## 102. EPoC PHY Link

*Modify Figure 102-1 and 102-2 as shown below*

Figure 102-4—Example, all subcarriers used for probing, no skipping

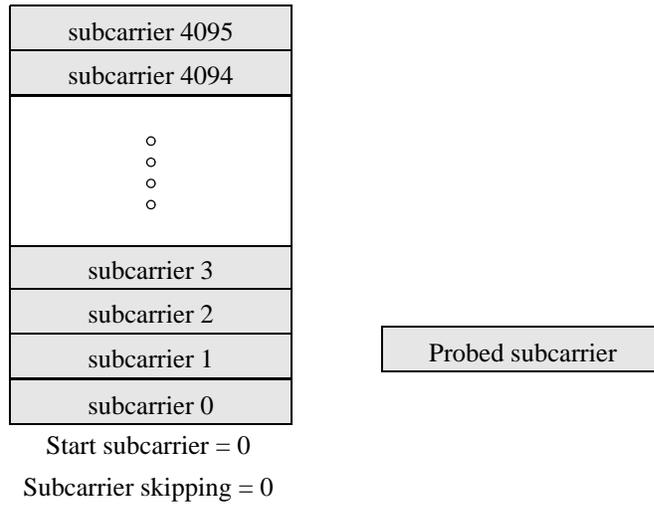
*Modify section 102.4.3 as shown below.*

The CLT allocates subcarriers within a probing symbol by sending five variables to the CNU: PrbStrtSC, PrbSkp, PrbEQ, StrtSym and SymNum (see 102.4.3.6). Figure 102–4 and Figure 102–5 illustrate the use of PrbStrtSC and PrbSkp. The CNU uses the start subcarrier and subcarrier skipping parameters to determine which subcarriers are to be used for probing transmission, as follows:

Figure 102-5—Example, alternate subcarriers used for probing

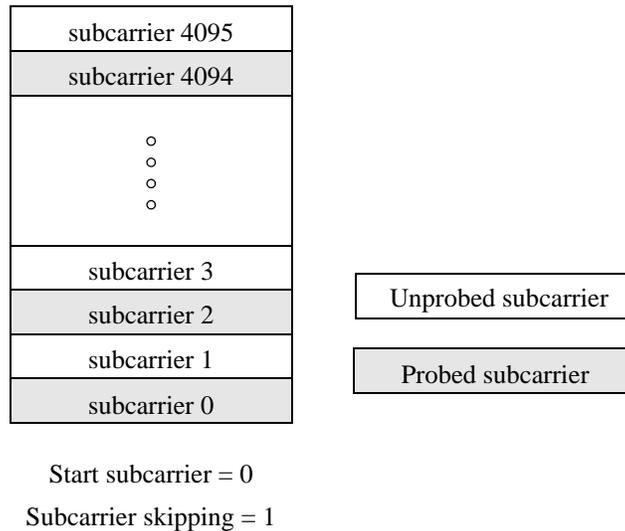
To schedule a single CNU in a probing symbol with skipping subcarriers to create nulls (as illustrated in Figure 102–5), the CLT does the following:

- 1) Allocate a specific probing symbol to a single CNU.
- 2) Set PrbSkp to a non-zero positive integer value.
- 3) Set PrbStrtSC to the number of the first subcarrier.

**Figure 102–6—Scheduling two CNUs in the same probing symbol**

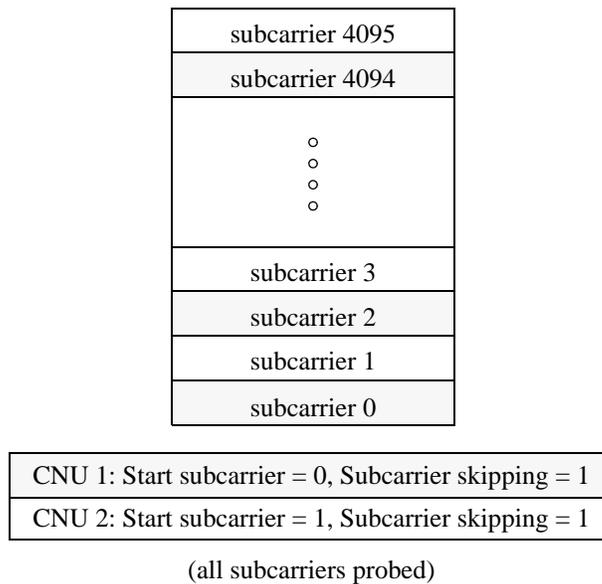
To schedule multiple CNUs in a probing symbol (as illustrated in Figure 102–6) the CLT does the following:

- 1) Allocate the same probing symbol at any given time to more than one CNU.
- 2) Assign a different PrbStrtSC number to each CNU.
- 3) Assign the same PrbSkp value to every CNU within the probing symbol.

This method can be used with or without skipping subcarriers to create nulls. To create nulls, specify a PrbSkp value equal to, or greater than, the number of CNUs in the pattern.

Figure 102–7—Probe sequence generator

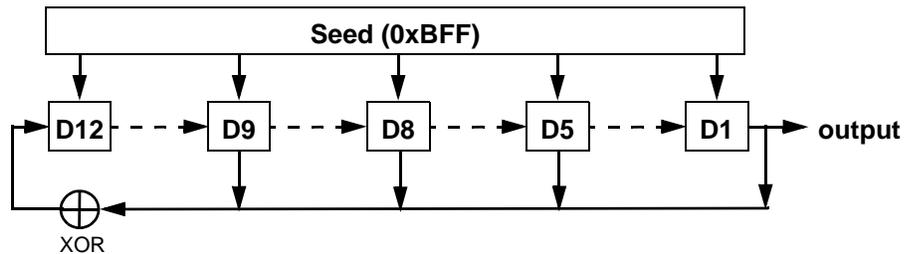
The Probe symbol shall be populated with a BPSK mapped bit sequence generated by a pseudo-random sequence generator defined by the polynomial  $X^{12} + X^9 + X^8 + X^5 + 1$  seeded with a fixed bit pattern of 0xBFF at the beginning of each upstream superframe (illustrated in Figure 102–7). The output of the sequence generator is mapped using BPSK modulation (see 101.4.5.2) where a bit value of 0 is mapped to a BPSK value of plus1 and a bit value of 1 is mapped to a BPSK value of minus 1.

**Figure 102–8—CNU Probe transmission control state diagram**

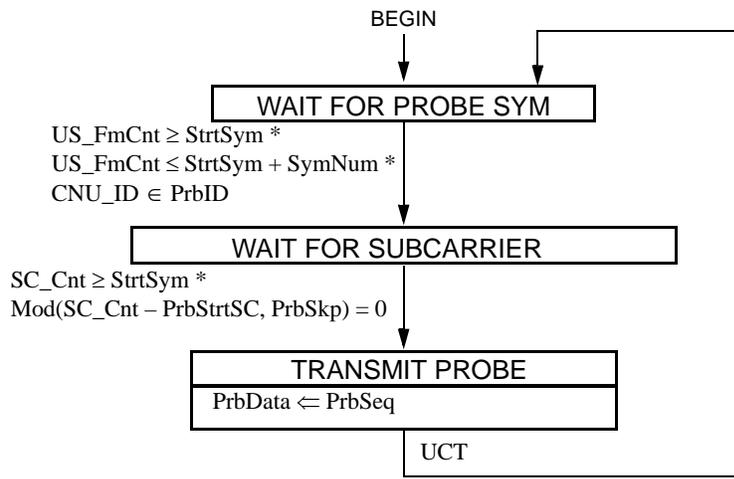
*Add section 102.4.3.6 through 102.4.3.9 as shown below.*

The CNU probe transmit process shall conform to the state diagram shown in Figure 102–8.

**Figure 102–9—PrbID update state diagram**

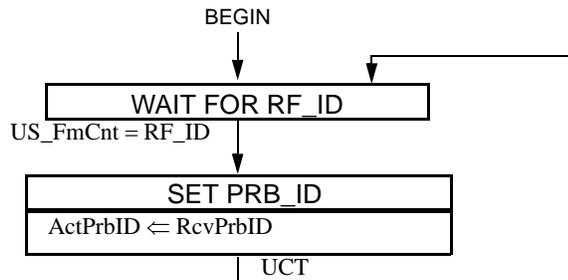
When this CNU\_ID is contained in this set of variables the CNU is allowed to transmit a Probe Signal per the Probe Control variable PrbEQ, PrbSkp, PrbStrtSC, StrtSym and SymNum. This set of variables is updated with each downstream PHY Link frame when RF\_ID = US\_FmCnt (See Figure 102–9).
